## **R44 SERVICE LETTER SL-47**

**SUBJECT:** Magneto Tachometer Points Wires

**ROTORCRAFT AFFECTED:** R44 helicopters S/N 1361 thru 2354 and R44 II helicopters S/N 10262 thru 13666.

FIGURE 1

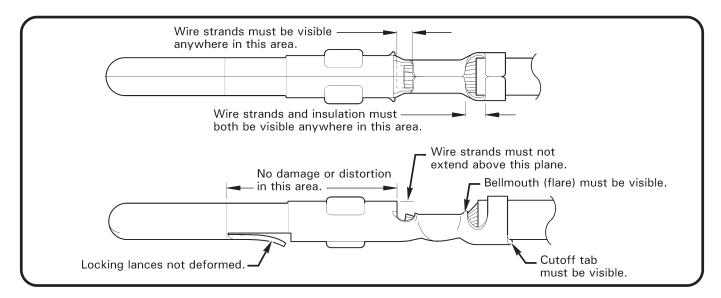
**BACKGROUND:** Damaged wire insulation has been found adjacent to the 2-pin connector at end of the magneto's tachometer wires. Damage occurred during trimming of heat-shrink at the connector.

- 2. If insulation is damaged, cut and discard adjacent ty-raps and disconnect wires at airframe harness connector. Cut both magneto wires to remove damaged wiring and discard pins, 2-pin housing, and heat shrink(s).

- 3. Strip magneto wires and crimp a B263-3 pin on each; inspect crimps per Figure 1 and verify security.
- 4. Insert pins into B263-12 2-pin housing; verify security. Polarity is not critical, and heat shrink is no longer used.
